MANDATORY SERVICE BULLETIN

MSB 42-120/3

Installation of an additional exhaust bracket.

WORK INSTRUCTION

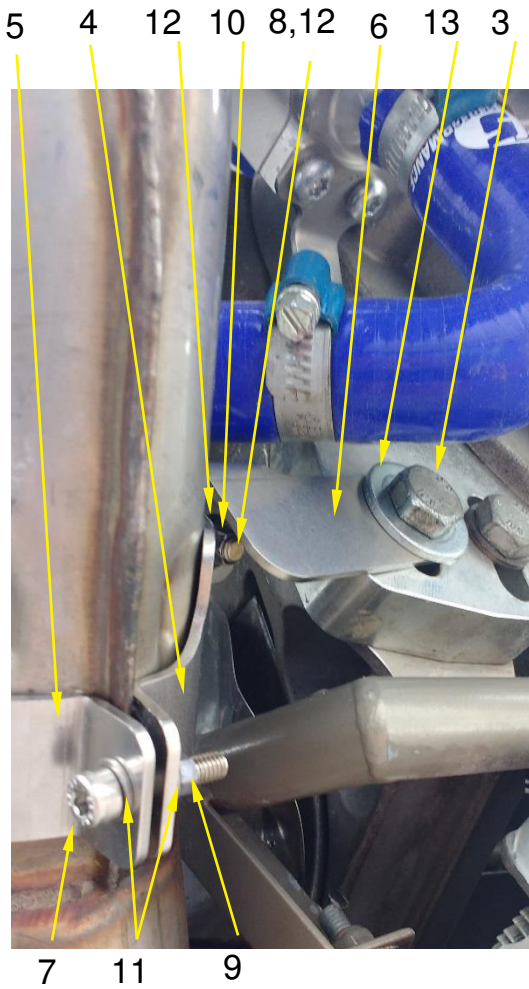
1	Remove engine cowlings in accordance with (i.a.w.) AMM section 71-10.
2	<p>Make sure that the intermediate flange of the engine is installed correctly to the forward engine shock mount. Align a ruler with the straight part of the bottom side of the intermediate flange as shown in the picture below. The distance between screw (pos. 3) and the ruler must be 13mm.</p> 
3	Remove the screw (pos. 3) from the front shock engine mount.

4

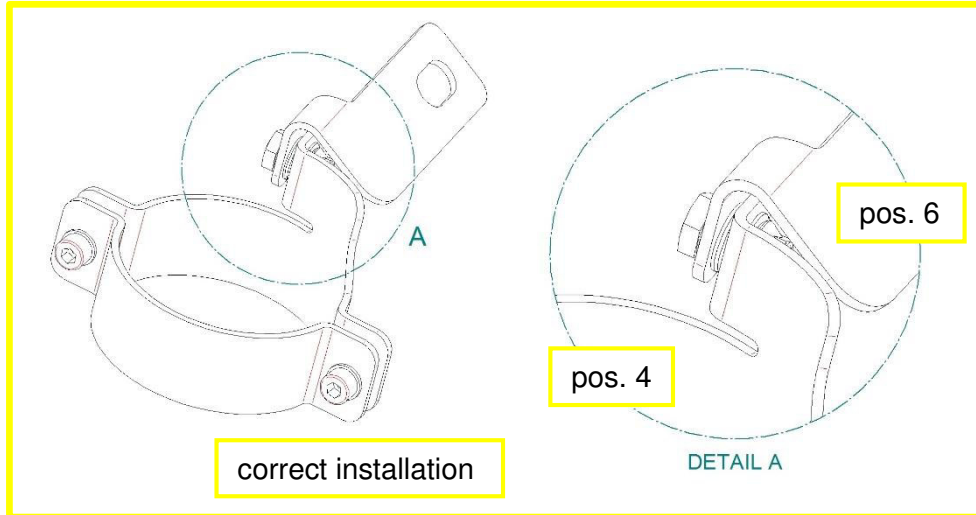
Install the exhaust clamp i.a.w. the pictures without tightening the bolts.

5

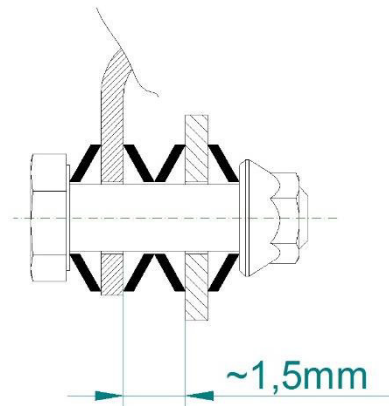
Make sure that exhaust clamp 1 (pos.4) and exhaust sheet (pos. 6) are arranged as shown in the following pictures:

Note: The correct order of arrangement is:
 hexagon screw (pos. 8) – spring washer (pos. 12) – exhaust sheet (pos. 6)
 – 2 x spring washer (pos. 12) – exhaust clamp (pos 4) – spring washer
 (pos 12) – K-nut M6 (pos 10)

7

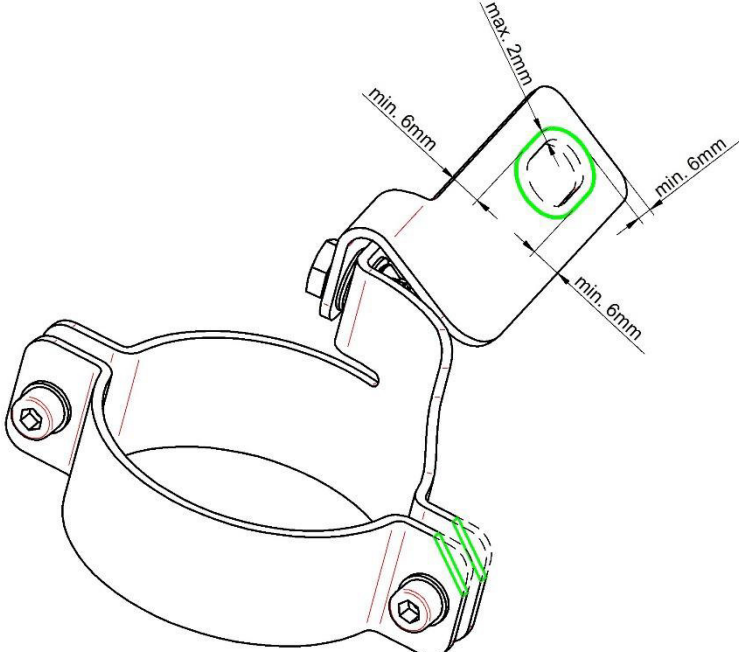
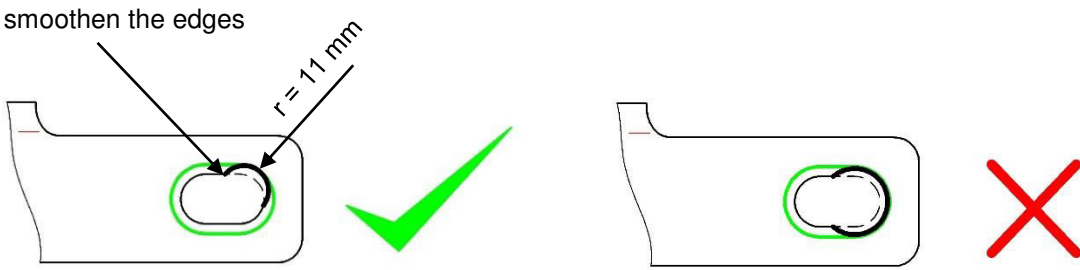
Tighten Hexagon Socket Head Screws (pos. 7) equally on both sides with 5 NM (3.7 lbf.ft.).
